TECHNICAL SERVICE BULLETIN

RE: Schwintek In-Wall™ Slide-Out System – 500:1 Ratio

Document Control Number: 34-03142016-0148

TSB Number:	11-001-16A
Product:	Schwintek In-Wall™ Slide-out System
Date:	March 23, 2016

Fig. 1

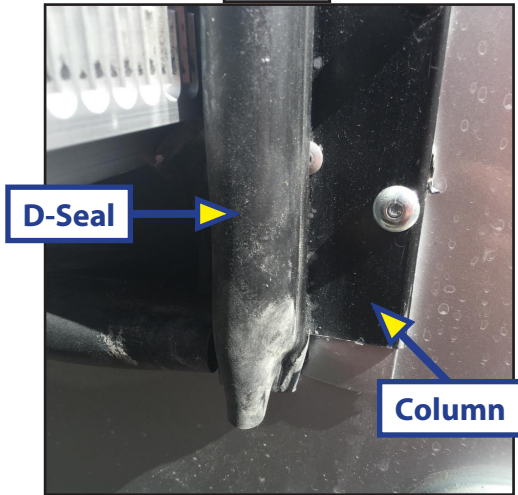
1. Extend the slide room approximately 18" - 24" to give enough clearance between the slide room T-molding and the side wall of the coach to perform the repair.
2. On the exterior of the unit, remove the screw holding the D-seal in place (Fig. 1). This screw is located at the bottom of the column assembly (Fig. 2A).
3. Slide the D-seal down and off of the wipe seal and set aside for re-installation.

Fig. 3

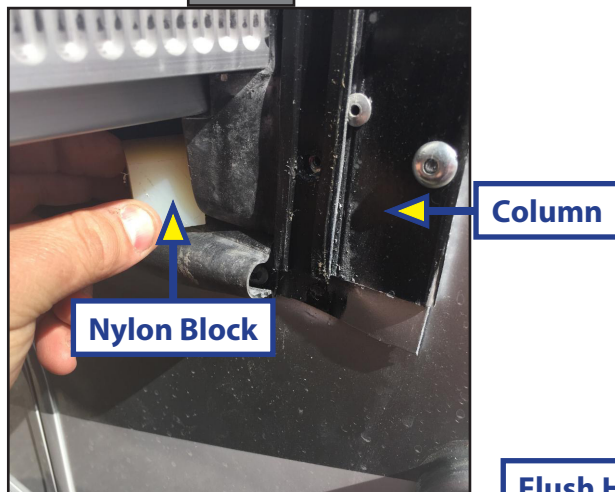
4. Position the nylon block inside the column, directly under the torque shaft (Fig. 3). The torque shaft may be flush with the bottom of the lower bearing block or protruding down by up to 1/4". Ensure the block is flush with the inner column walls on the exterior face, and the side wall face (Fig. 4).

Fig. 8

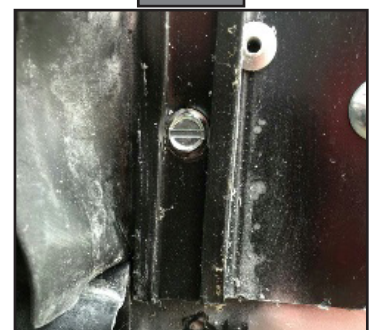
- Remove the nylon block from inside the column. Remove any drill debris from the nylon block and inner column surfaces (Fig. 7). The nylon block and column surfaces **MUST** be clean and free of debris to allow the nylon block to sit flush against the column wall.
- Position the nylon block inside the column again. Ensure the drilled hole in the block aligns with the drilled hole in the column.
- While holding the nylon block tightly in position, install the #10 x $\frac{3}{4}$ " screw through the previously drilled hole in the column and into the nylon block (Fig. 8). Make sure the nylon block is flush with the inner walls of the column and that the bottom of the screw head is flush against the exterior column wall (Fig. 9).
